SERVICE BULLETIN

SUBJECT: REPLACEMENT OF DRIVE STEEL ROPES OF RADIAL ARMS.

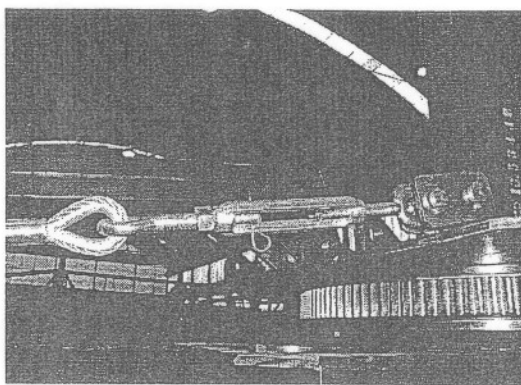
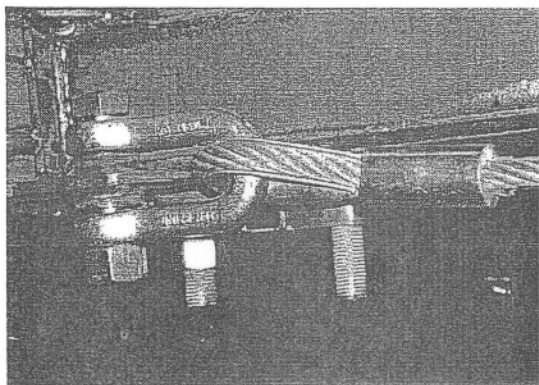
All driving steel ropes (total q.ty 8 ropes) are to be replaced with the new ones. Each old roping (consisting of a steel rope, a clevis, a tightener and the related bolts and nuts) must be removed keeping the threaded piece of the tightener.

The new ropes shall be installed according to the following pictures:

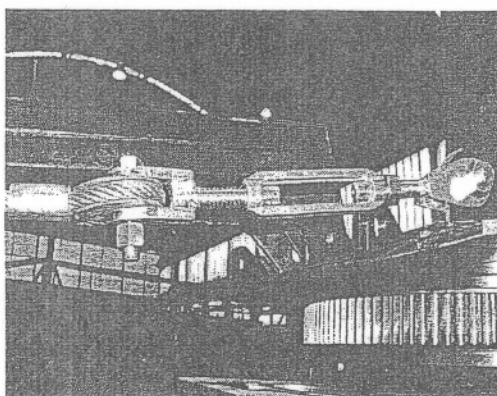
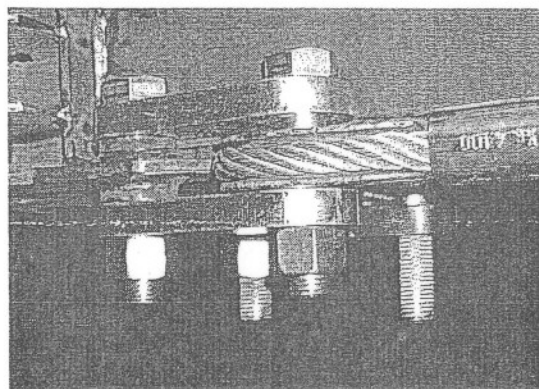
The tightener must be locked by two 4mm clips each after adjusting the ropes' tension.
